Comment on 2015/4757/P, 15 Wilmot Place, NW1 9JP
Rochester Conservation Area

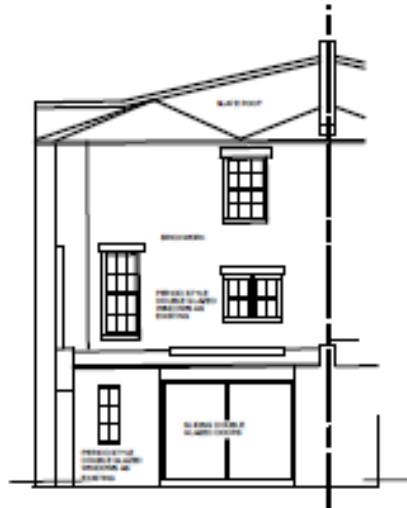
The top of the back extension, and the upper rear of the house are visible to pedestrians in Rochester Place, and therefore of conservation concern.

The information provided is partly unclear. The 'existing' photo, below shows an original sash staircase window, but the other two windows are part of the twentieth century rebuilding in shape and materials. The 'proposed' drawing, shows smaller lintels and different glazing bars at first and second floors. If this indicates new sash windows, this would be welcome if they follow the style of other original windows in the row. (At this period, Victorian houses tended to have two or three panels per sash, not the single panel as neighbouring No14 at first floor.)

The proposed large plate glass windows at garden level are out of character for the building. Since this is to be the breakfast room, it will have table and chairs that will partly block access. As there will already be more light from the skylight, a balanced proportion could be a central single glass door and window to the side.

- Details of the construction and materials for the doors, windows and rooflight should be approved for conservation quality
- Demolition of part of the external and the internal wall of the extension adjacent to No 14 requires conservation area permission.
- As there will be internal works ('strengthening floors) and new plumbing, it would be welcome to use the opportunity to re-site the external soil pipe which currently crosses the side wall.
- The satellite aerials at the junction with No 14 Wilmot Place should be removed.
